Application 2026/91657 – Clarification required regarding external-wall return at Plot 23

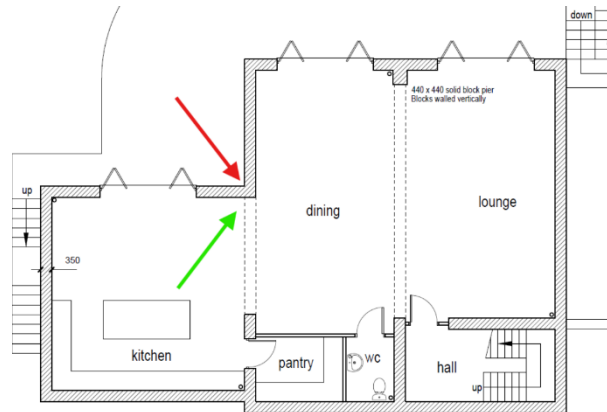
The submitted floor plan appears to show a solid external wall turning through approximately 90 degrees at this location. The attached plan identifies the relevant junction with a red arrow and shows, with a green arrow, the approximate direction from which the accompanying photograph was taken.

The construction currently visible does not readily correspond with the masonry return represented on the plan. The facing stonework terminates in a notably neat, straight vertical edge. The adjoining blockwork does not presently appear to form the projecting return shown on the drawing, nor is there any obvious continuation of the facing stone around that corner.

This raises a legitimate possibility that a separate framed, clad or otherwise non-masonry element may be intended at the kitchen/dining junction, or that the completed external form may differ from the submitted drawing.

I therefore request that the Local Planning Authority obtains a detailed drawing of this junction showing:

- the precise wall line and dimensions;
- the proposed masonry return;
- how the facing stone is to continue around the corner;
- the relationship between the facing stone, cavity and blockwork;
- any frame, cladding, infill panel or separate construction element intended at this location;
- the final external materials and appearance; and
- confirmation that the completed built form will accord with the submitted plans and elevations.
